City of Oshkosh Water Filtration Plant Clearwells Replacement Project Aesthetics Ad Hoc Committee Meeting #3

Date: June 29, 2023
Project name: City of Oshkosh Water Filtration Plant Clearwells Replacement
Prepared by: Jacobs Engineering Group (Jacobs)
Location: City Hall, Room 404, 4:00 – 6:00 PM
Participants: Ad Hoc Committee Members: Brad Spanbauer, Aaron Scherer, Lauren Bartelt, Kirsten Buckstaff, Bill Wyman
Committee Staff Liaisons: James Rabe, Jason Ellis, Mark Lyons, Aaron Dressler
Jacobs: Linda Mohr
Copied: Chris Anderson, Brian Schuldes, Ray Maurer, Steve Gohde

**SOUTH LAKE SHORE DRIVE
ALTERNATIVE #1**
ONE-WAY YEAR ROUND WITH SEPARATE PEDESTRIAN/BIKE TRAIL

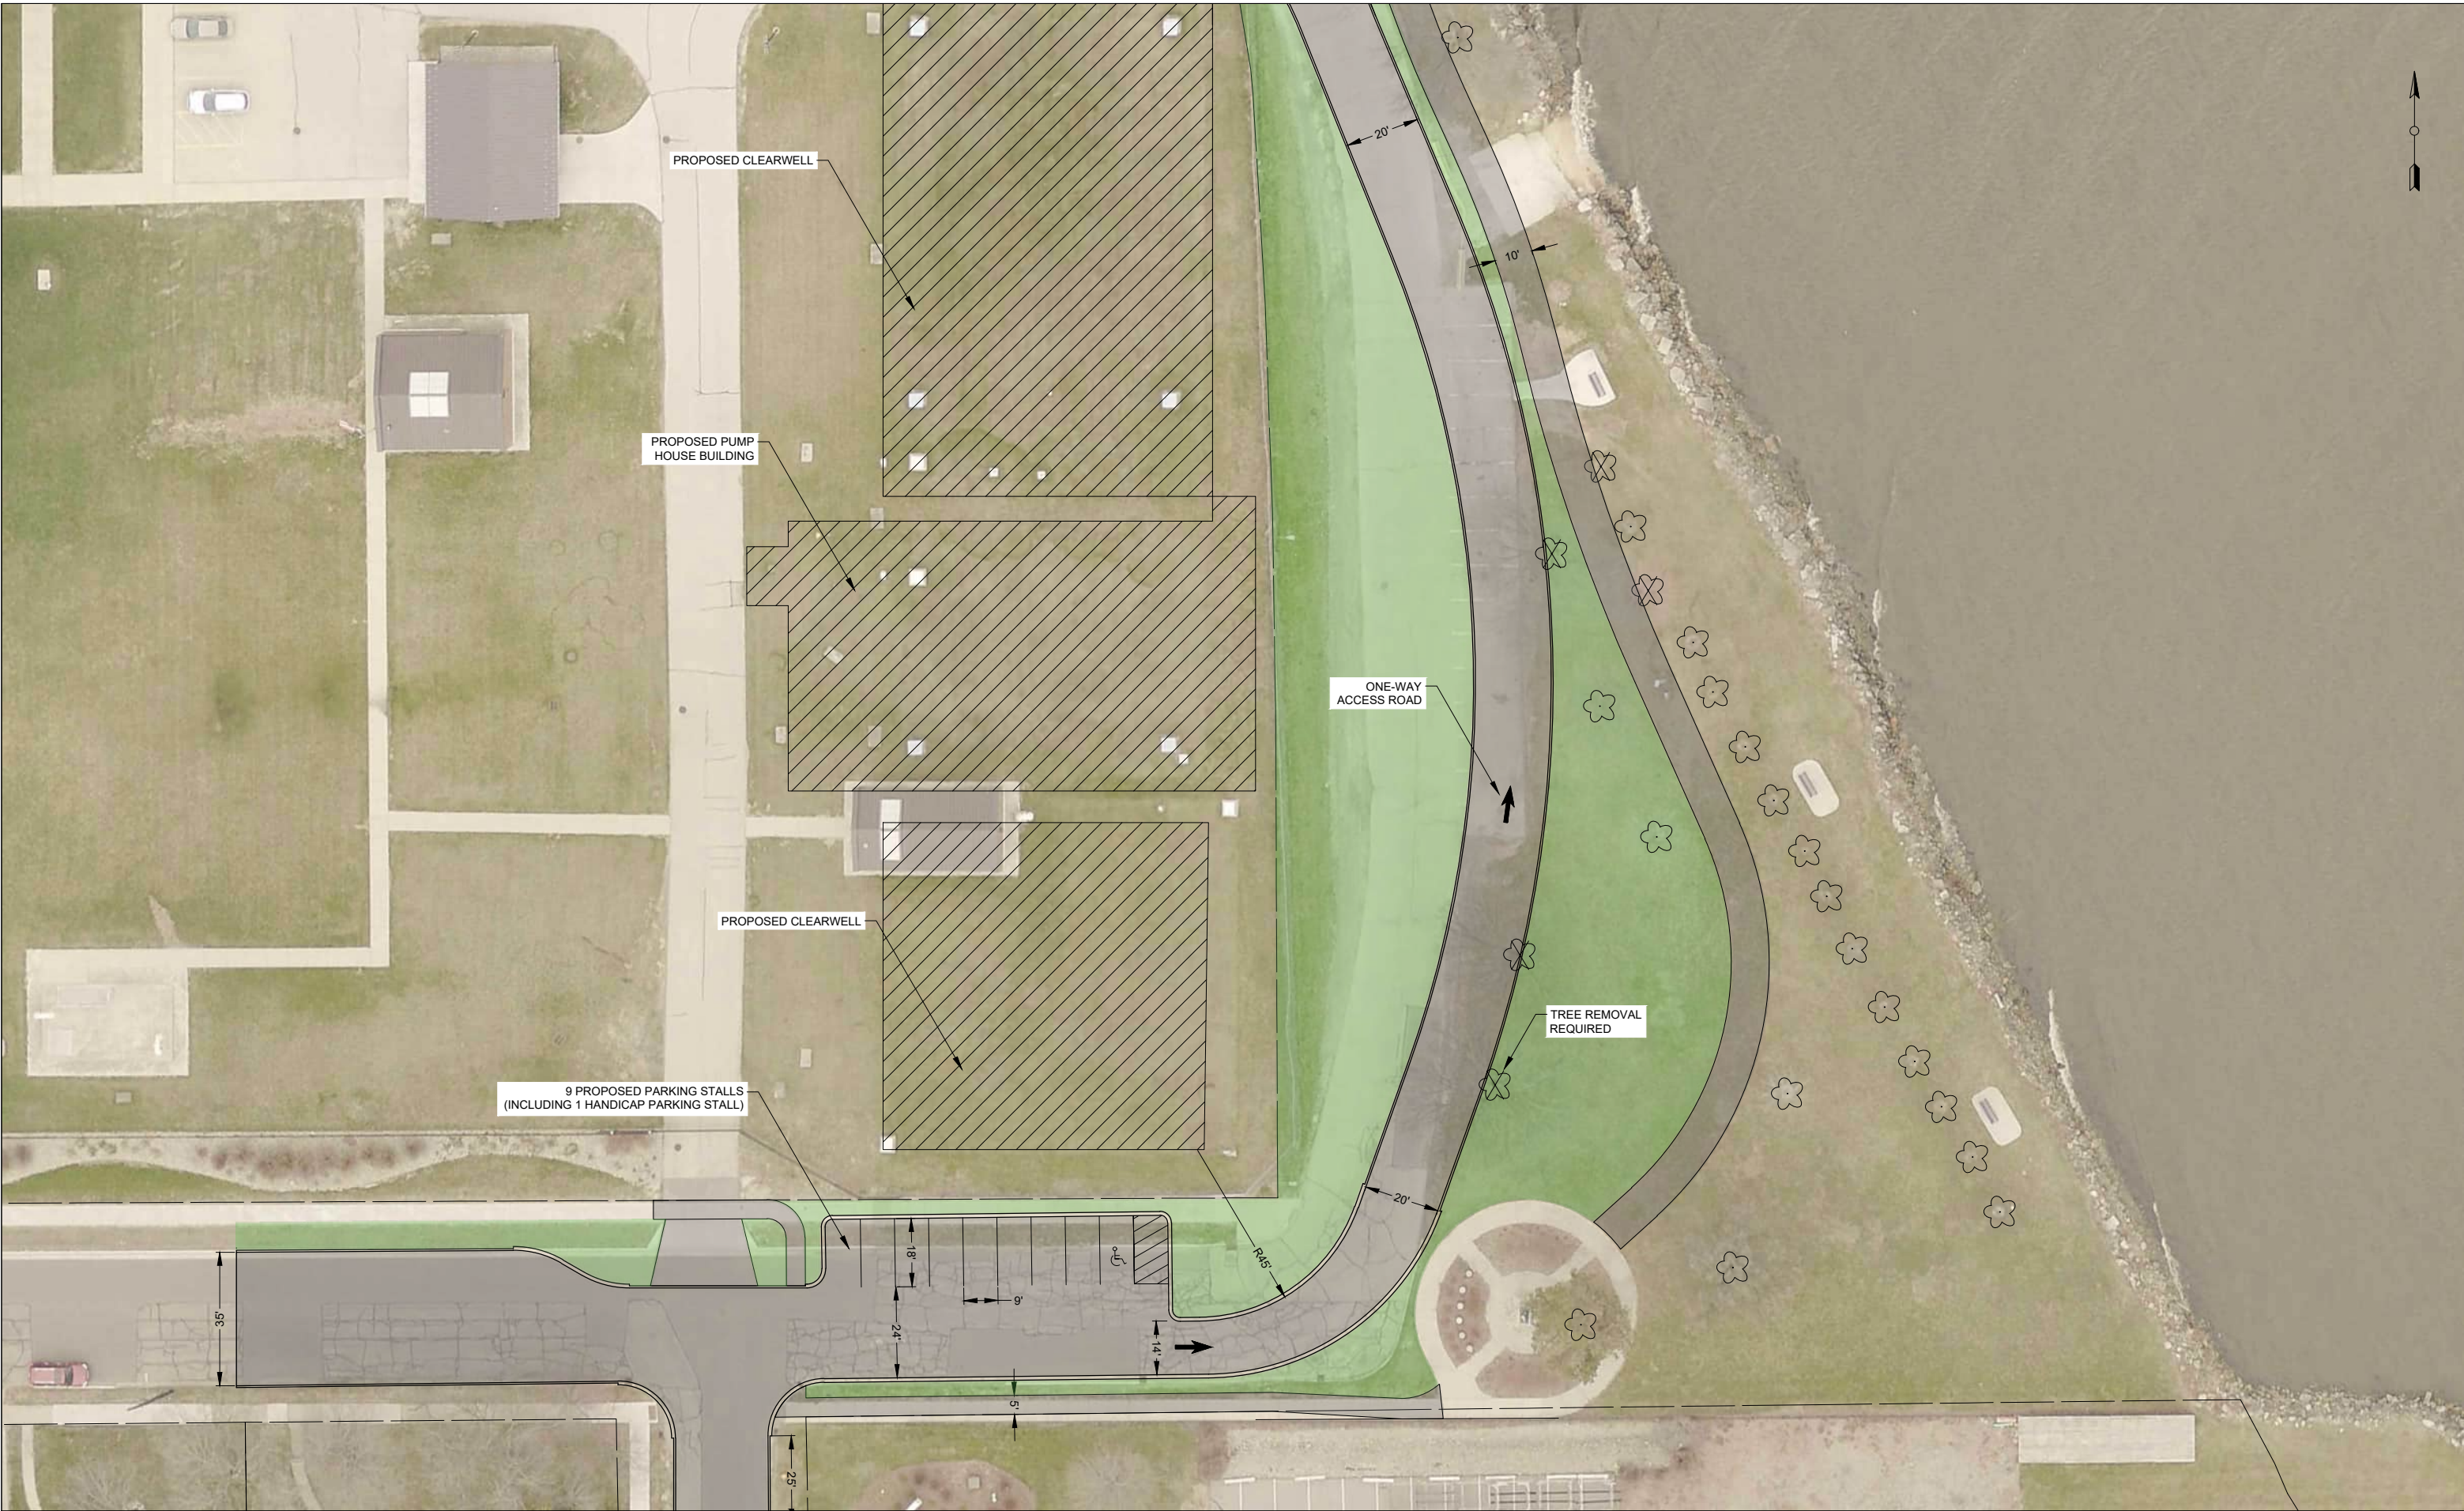
- James said the City is still working on potential layouts for the northern portion of Lake Shore Drive which will provide 2-way vehicular access.
- Committee members didn't care for new parking on east end of Washington Avenue and would prefer parking be added on north Merritt Avenue as shown in Menominee Park masterplan figure included in Committee Meeting #2 minutes. Committee members are interested in green parking (permeable pavement) if possible.

- There are currently 48 parking spots along Lake Shore Drive. The Committee acknowledges these parking spots are used, but some reduction in parking on Lake Shore Drive is acceptable.

- The new pedestrian-bike path should connect with the existing path in Menominee Park. Educational signage (along new path and extending into Menominee Park) could provide information on the lake, lake ecology, or culturally significant sites like native American mounds and the 1915 clock tower.

- The Committee prefers the pedestrian-bike path be near the water rather than the treatment plant.
- In the final landscaping design, mature trees should be saved if possible. It's o.k. if the crabapple trees in the Park Area are removed. Some of the Park Area trees are "memorial trees" and will require additional consideration.

Action item: City team will look into whether the parking spots on north Lake Shore Drive can be shift a bit to west to make space for a water-side pedestrian-bike path, and still all cars to pull in and look at lake and still provide enough space to make chemical deliveries to plant.
